**AGENDA
FARRAGUT MUNICIPAL PLANNING COMMISSION**

**March 15, 2018
7:00 p.m. Farragut Town Hall**

**SUBJECT: STAFF COMMENTS ON THE SITE PLAN FOR THE AT HOME,
11501 PARKSIDE DRIVE**

**SUBJECT: STAFF COMMENTS ON THE CONCEPT PLAN FOR THE
BROOKMERE SUBDIVISION, PARCEL 044, TAX MAP 152, 430 VIRTUE
ROAD**

Preliminary Site Plan – Farragut Storage, 11775 Snyder Road, Zoned C-2 (Regional Commercial).

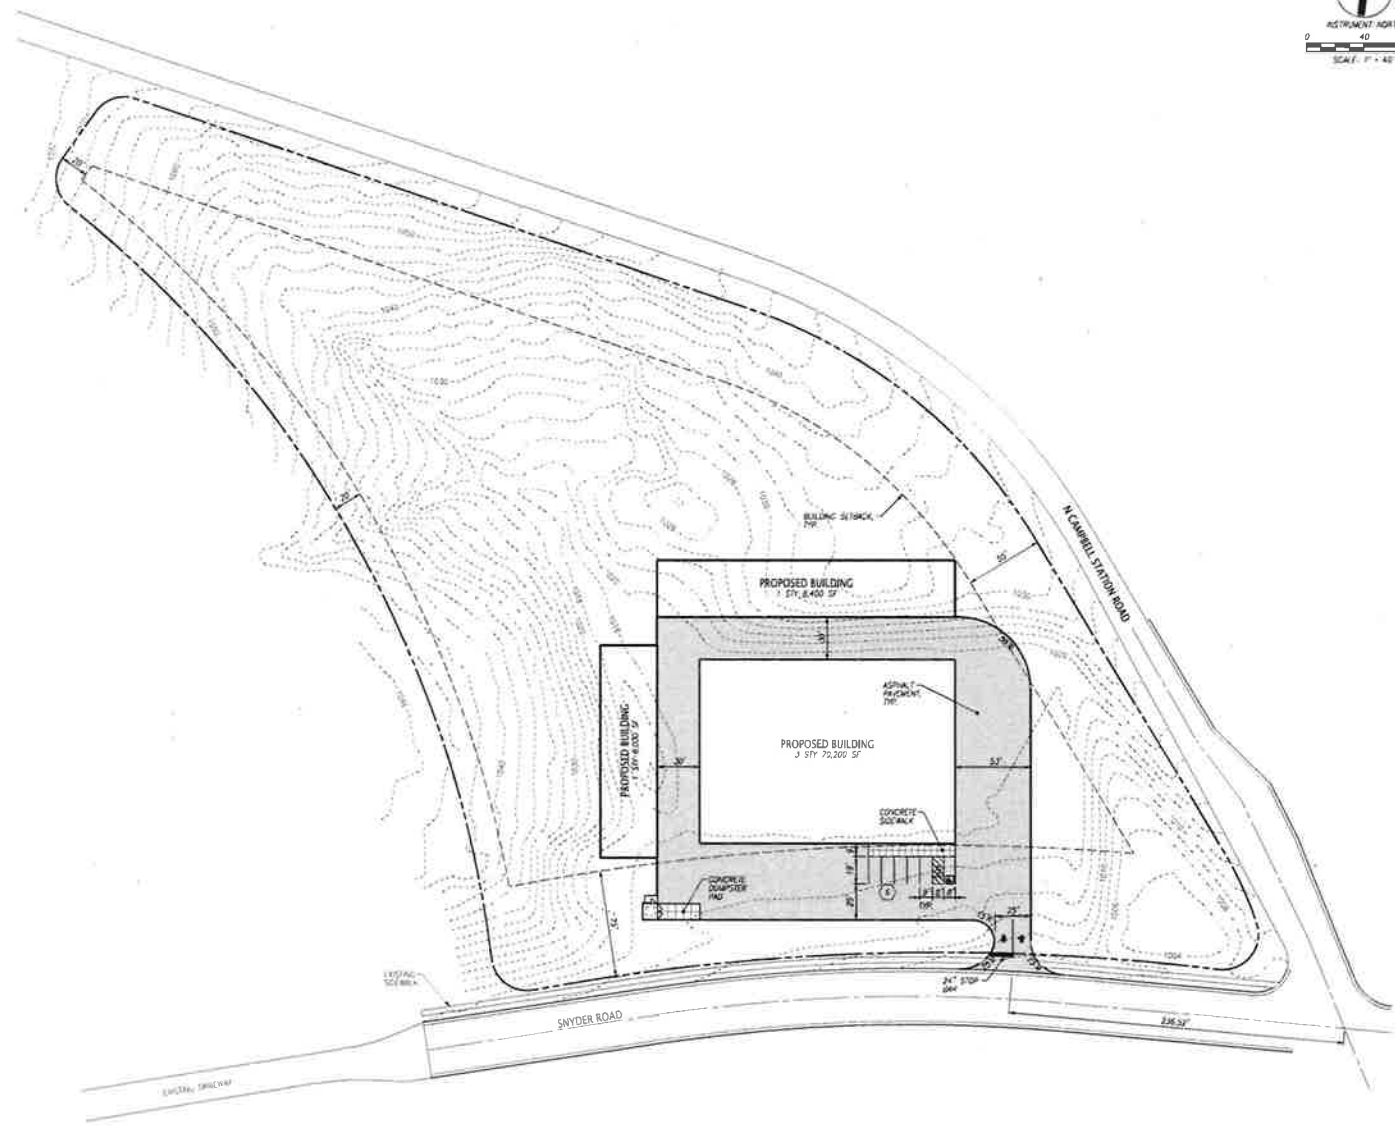
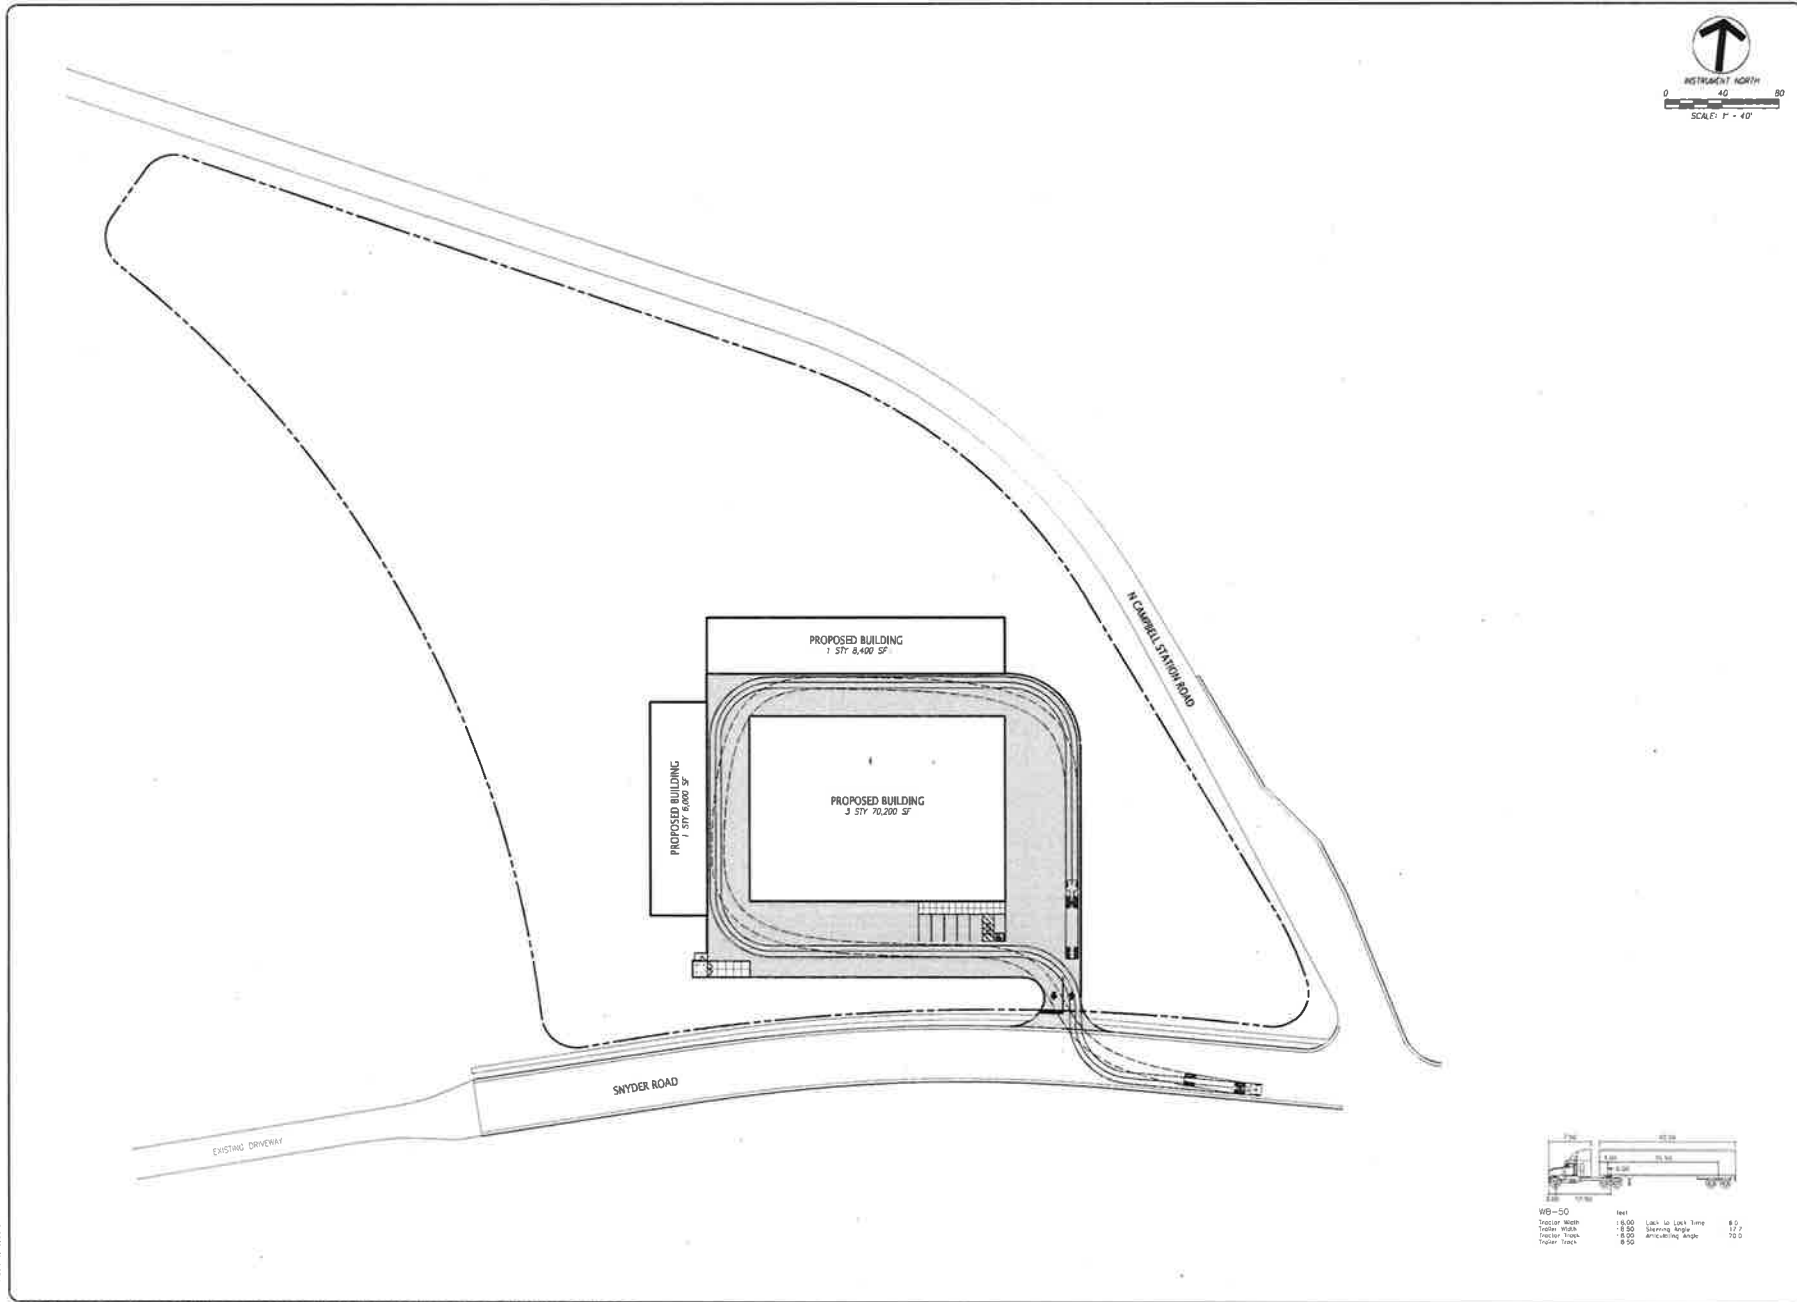
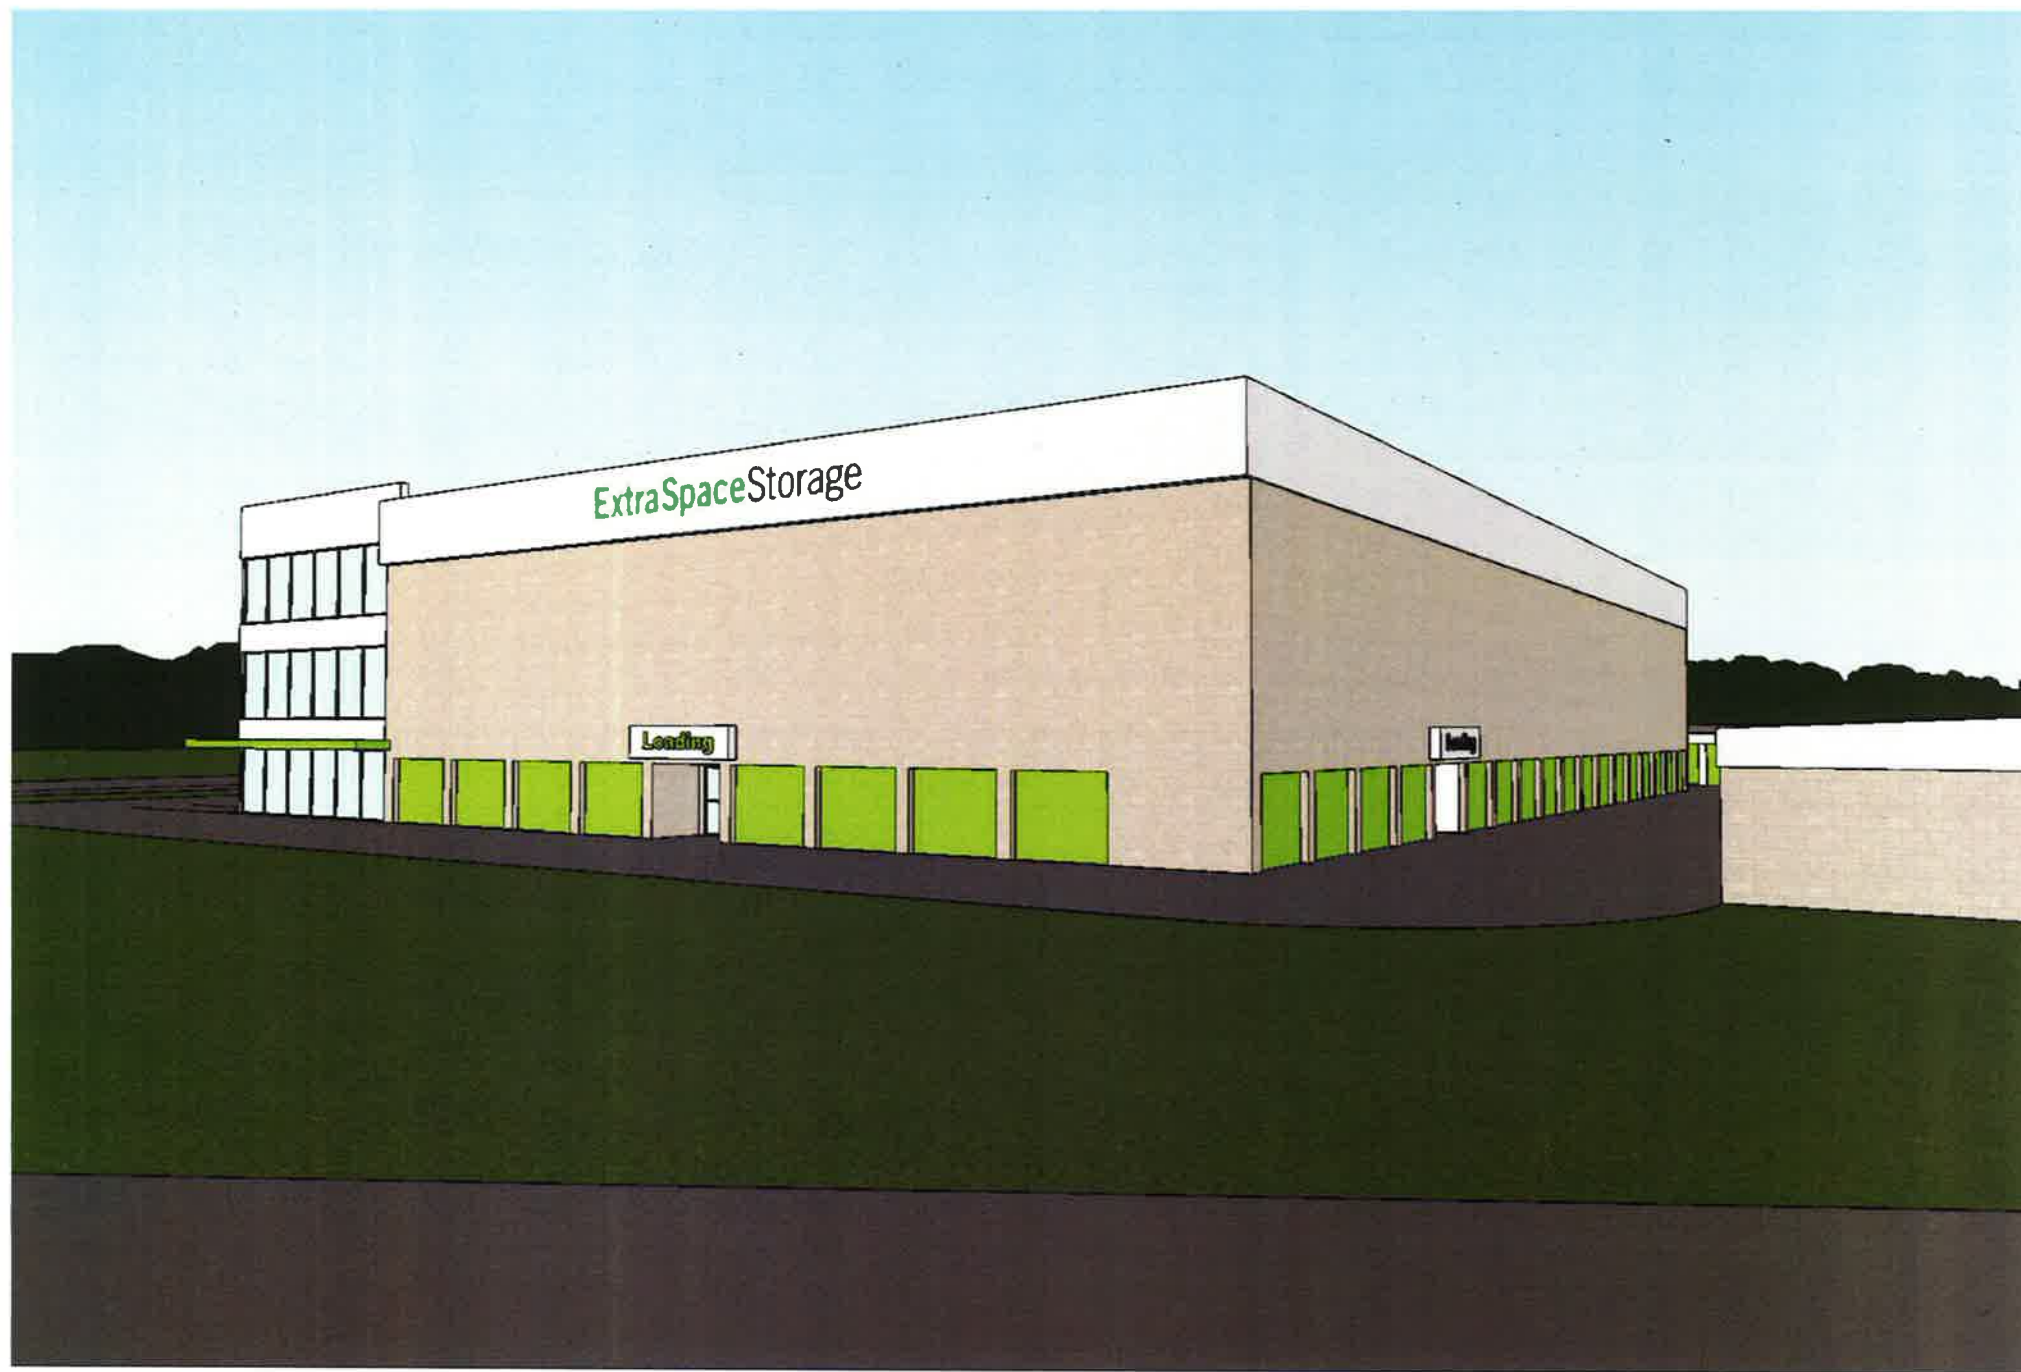
- 2) The plan does not address vehicular and pedestrian connectivity. The provision of connectivity is complicated by topography and, more importantly, by the location of the potential future road ROW to the west. Vehicular connectivity may not be practical in this instance.

- 3) The site plan includes significant paved surfaces and does not address the Town's requirements for low-impact stormwater management provisions. In addition, staff questions the minimum turning movements needed on the site and whether the amount of paved surface could be reduced?

- 4) The materials submitted do not provide enough detail to adequately address the Architectural Design Standards. The facility will have to comply with these standards and the applicant's architect will be required to complete the Architectural Design Standards Checklist as part of the full site plan submittal.

- 5) The Town's parking standards do not specifically provide a parking ratio for mini-storage / self-storage facilities. Under the ordinance, the matter will need to be referred to the BZA for a determination.

Site Area Plan
Building Expansion for
11501 Parkside Drive
Farragut, Tennessee

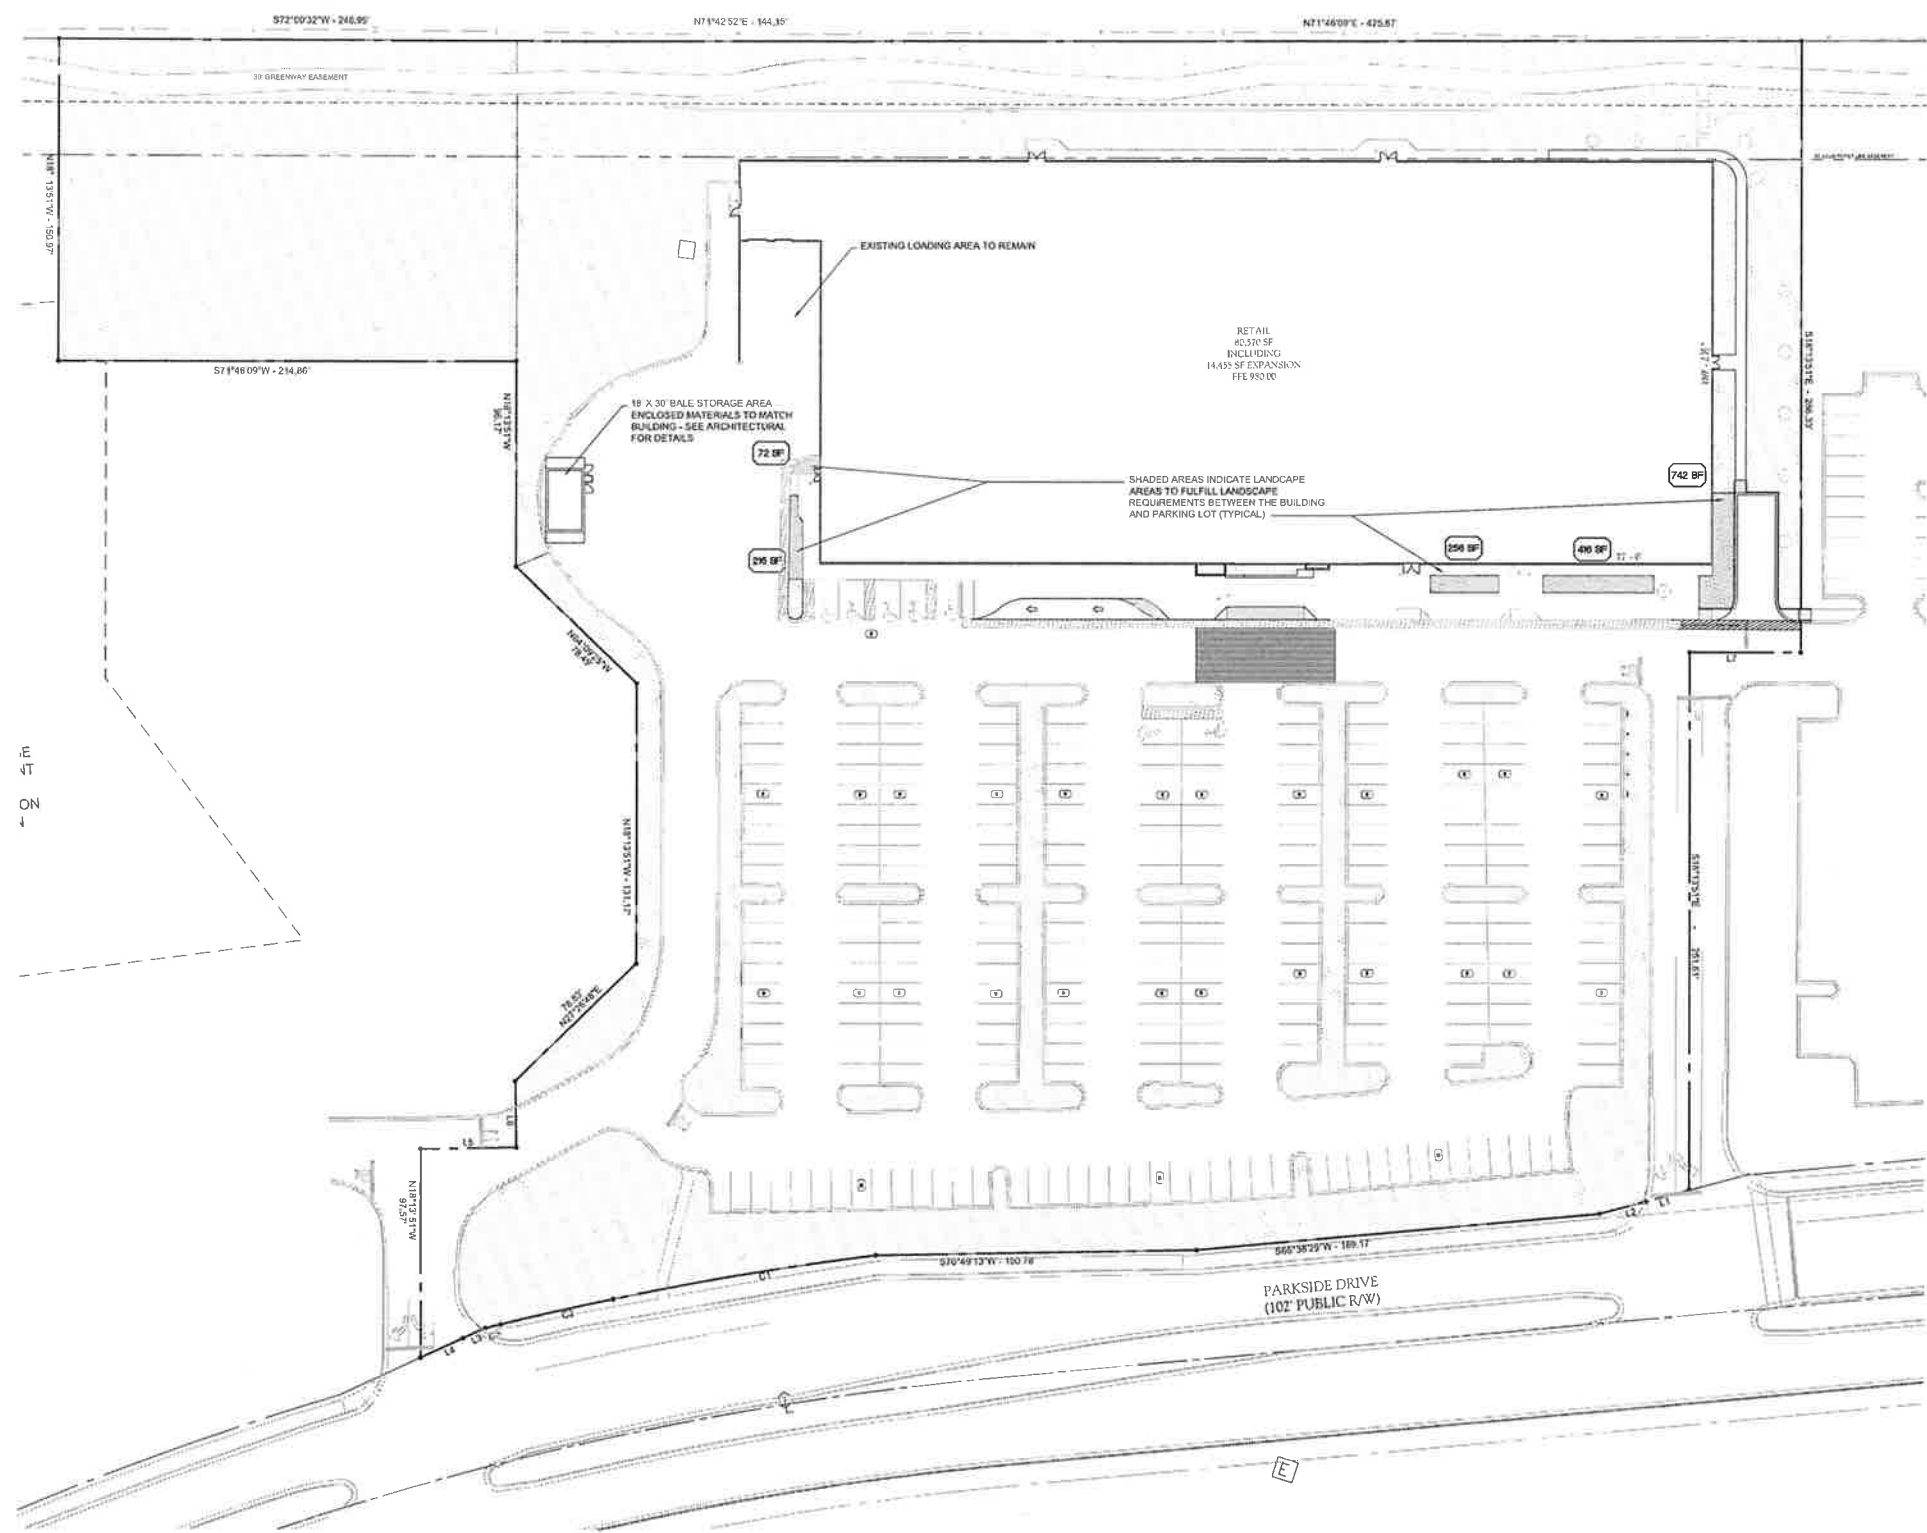
- 14) Please clarify "loading area" on the west portion of the front of the building;
 - 15) Please verify that any modified parking lot area is at least 10 feet from the nearest side property line (on west side);
